PERKINS+WILL**MMC East Tower Expansion – City Design Comments**

To:	Al Green
From:	Jeffrey Keilman
Date:	March 19, 2018
Subject:	MMC East Tower Expansion – City Design Comments – Workshop 2 Response
Attachments	MMC IDP Design Review_prelim2

Re: MMC East Tower Expansion – City Design Comments – Workshop 2 Response

East Tower & Visitor Garage Overbuild As Seen from I-295
Date: 03/23/2018

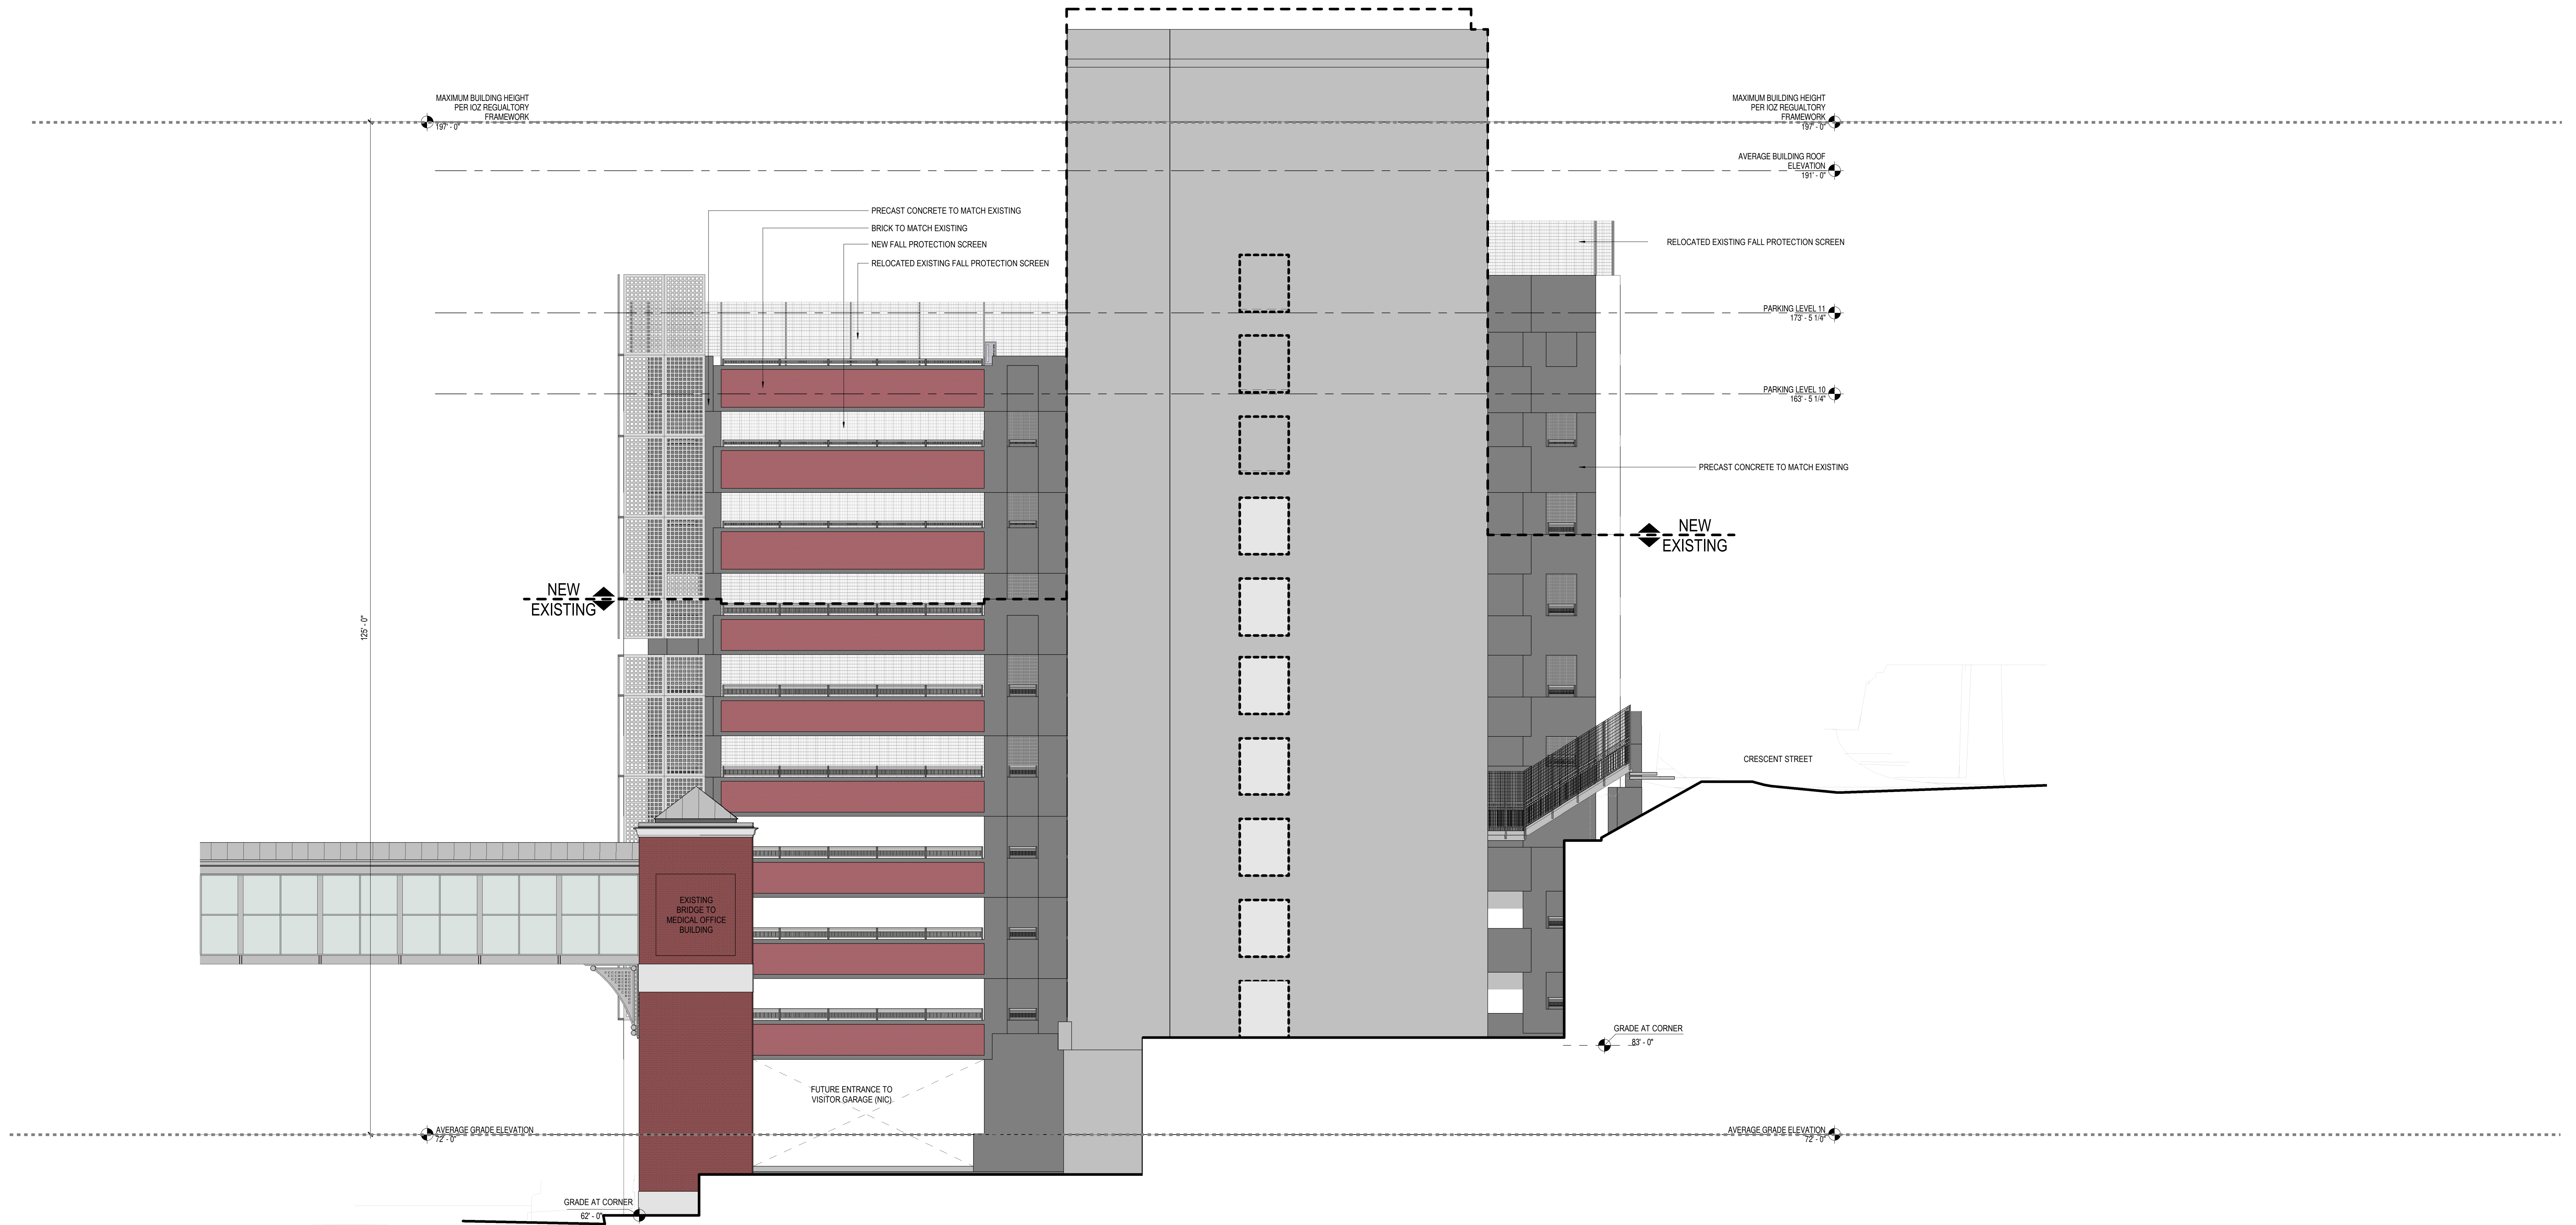
East Tower: *Planning Board generally found that the proposal is cohesive with the future vision as presented in the 2/27 materials.*

Visitor Garage: *Congress Street is a major street and this building will become even more visible from long views as it grows in height. The garage proposal lacks visual interest from long views – articulation and visual interest are important for the garage in the forefront of the campus. Planning Board asks that the applicant re-evaluate the approach. Although staff and Planning Board acknowledge it is not realistic to completely redo the siding of the garage, consider options like adding decoration to give three-dimensional life to the façade, laser cut metal panel. The roofline is an element where visual interest could be added - Planning Board commented that the simple roof form does not have enough visual interest for the long views.*

City Staff had no further comments or responses in regards to design approach and composition in regards to East Tower expansion within context of current and future expansion of Bramhall campus during the (2) subsequent meetings. An additional long view of Bramhall Campus was developed after the 03.15.2018

meeting as requested by the City Staff to further reinforce East Tower connections with previous Bean 2 Addition and future Congress Street development.

Design team developed long views to indicate the visual interest created by the East Tower addition, in particular with the current Surgery 2 Addition and future Congress Street Development. The roofline of the East Tower Addition was kept simple to not compete with the current composition of various rooflines on campus. The helipad was also a key driver in maintaining a simple approach are various create series safety concerns.

NORTH ELEVATION

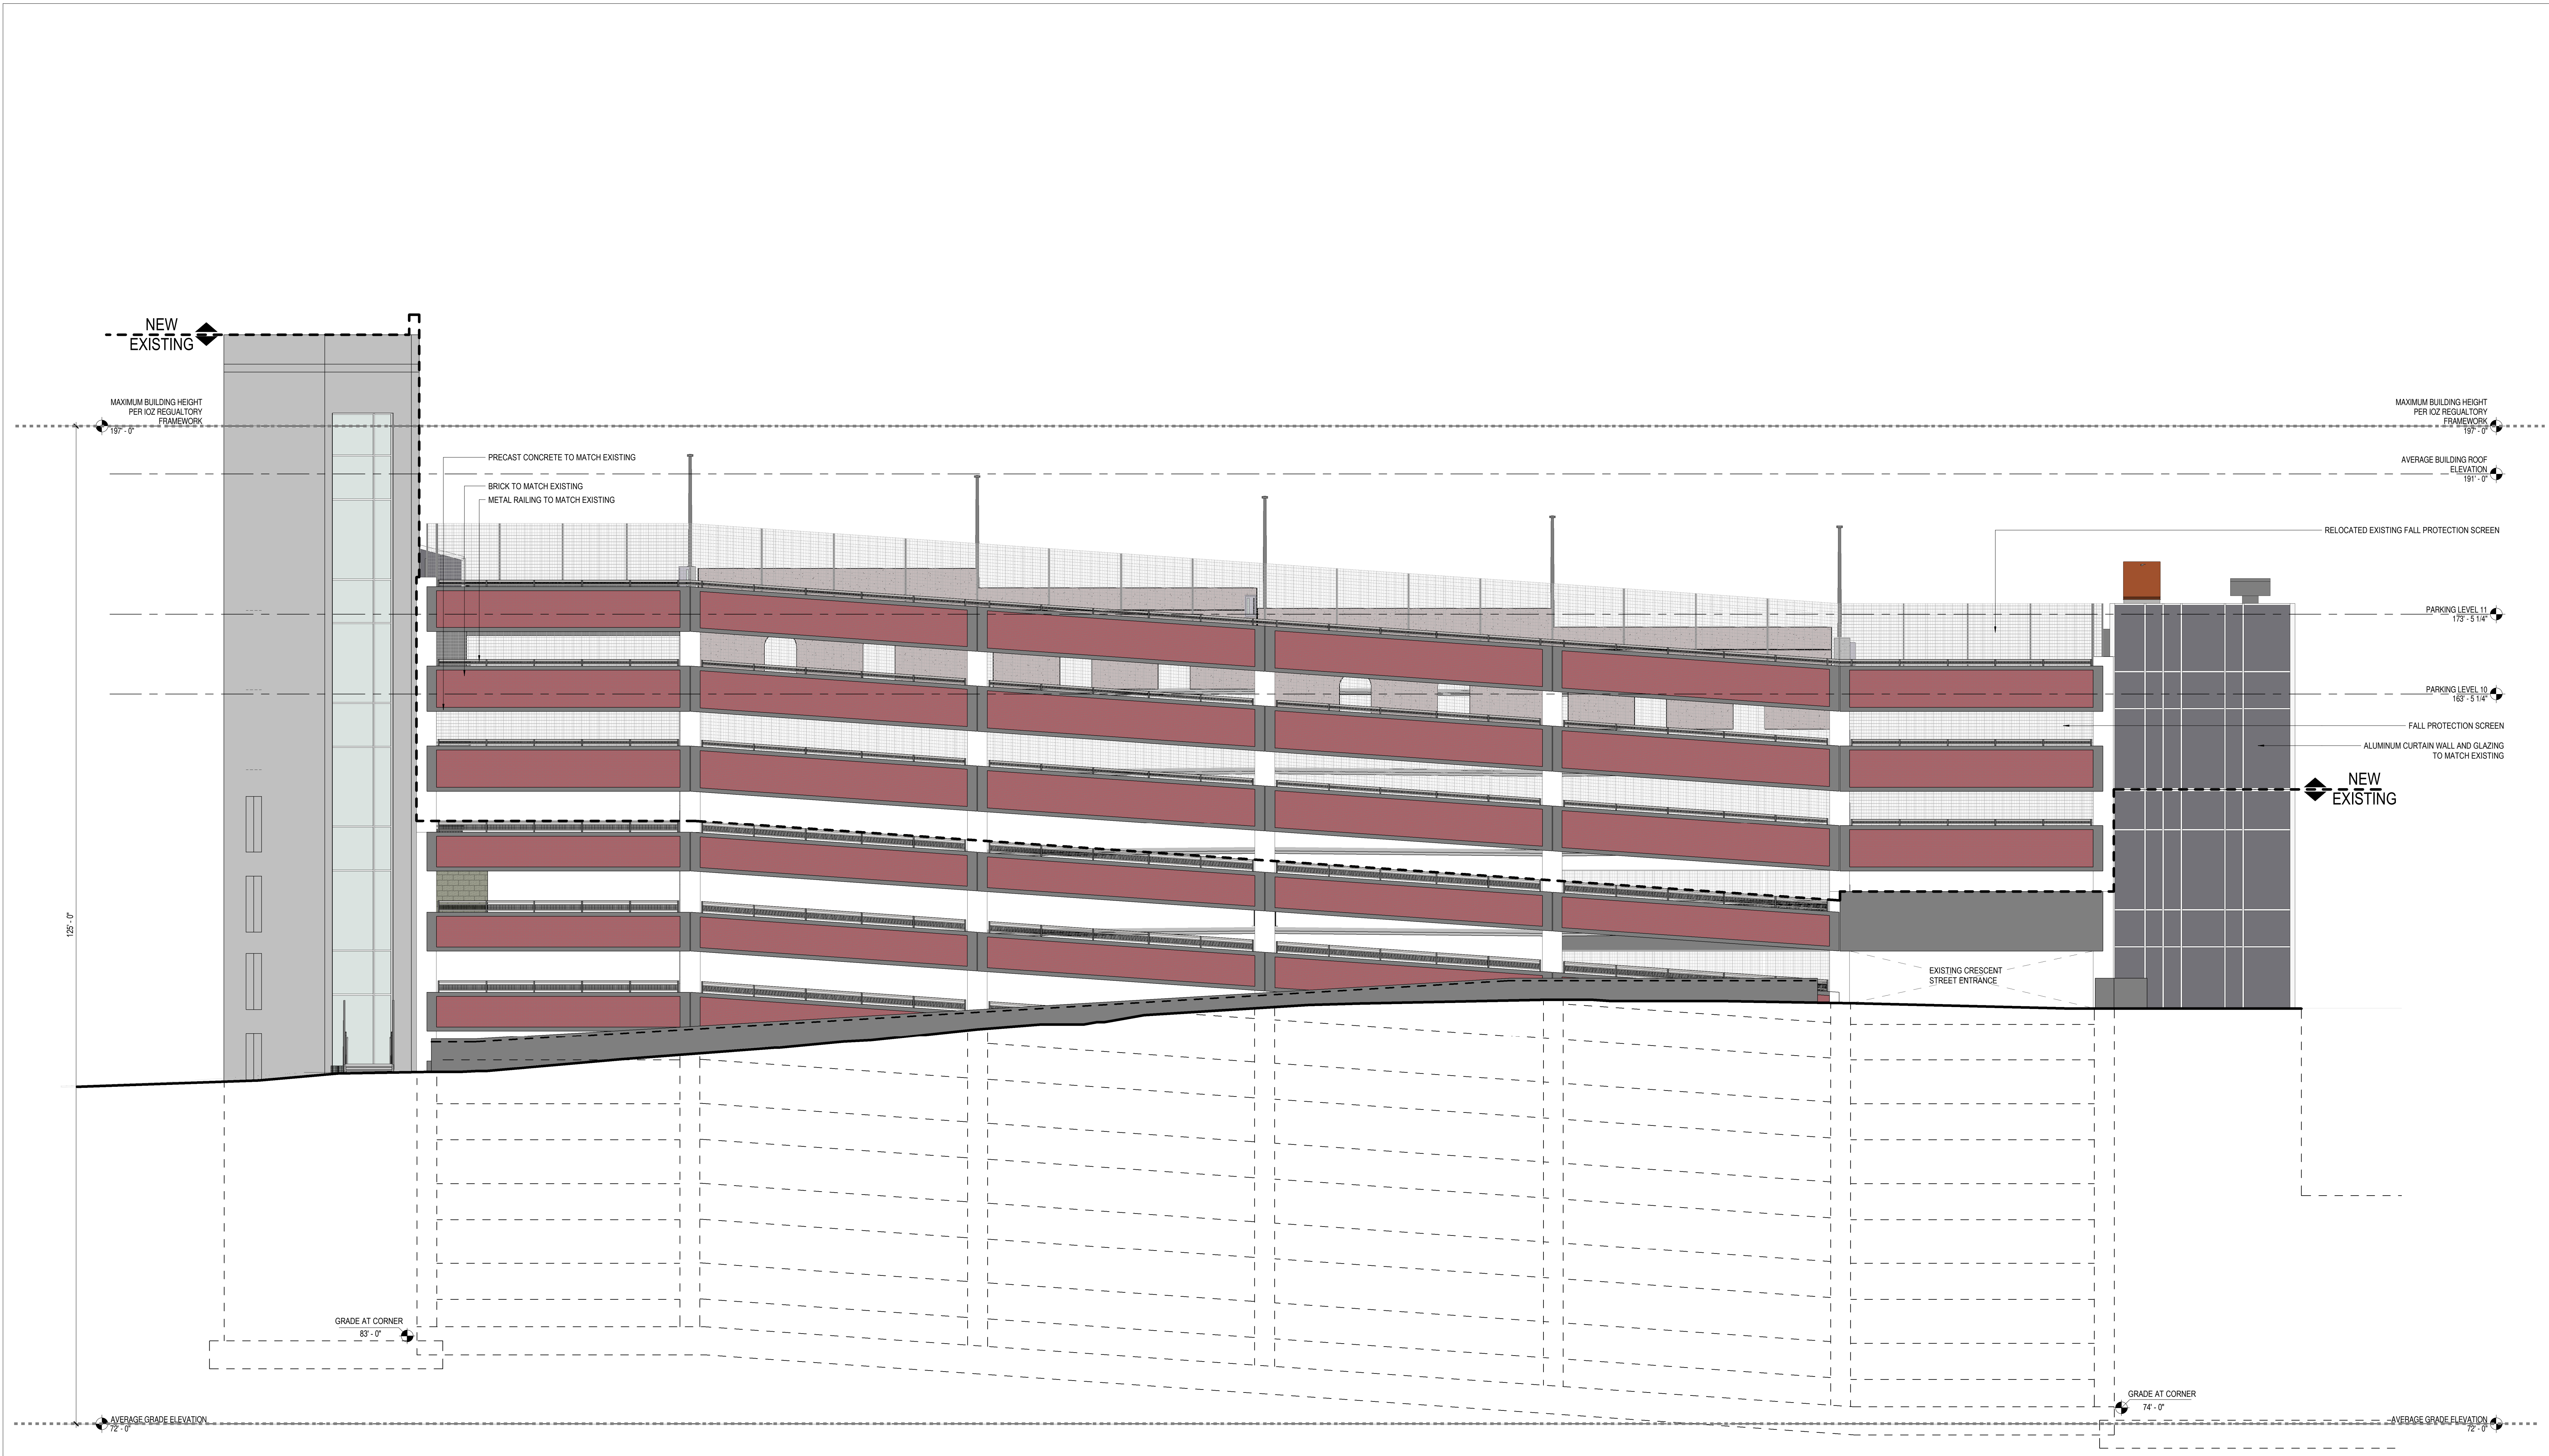
Visitor Garage: The proposal maintains the existing material palette of brick, concrete, and metal screen. *Planning Board is concerned about the prominence of the garage on Congress Street and the lack of visual interest and contribution to the public realm by using the existing material palette.*

Planning Board commented on the lack of visual interest on upper floors and feel this guideline is not met – roofline, façade material, fall protection/screen design are possible architectural elements that can address this guideline. Street activation guideline is met, see comments 7. above.

In response to comments as heard from the Planning Board and reiterated by City Staff, options were developed on how to modify the existing screening elements on the garage. Upon review, an option that extends the screening above the last spandrel panel was desirable by all that reviewed for it broke the horizontal plane of the roof line and created a layering between the screens, fall protection, and precast concrete panels.

Long views were developed for further review per recommendation of City Staff. The expansion of the Visitor Garage does increase its height but the ability to see the expansion is limited from long views. However, per comments as heard from the Planning Board and reiterated by City Staff, options were developed on how to modify the existing screening elements on the garage. Upon review, an option that extends the screening above the last spandrel panel was desirable by all that reviewed for it broke the horizontal plane of the roofline and created a layering between the screens, fall protection, and precast concrete panels.
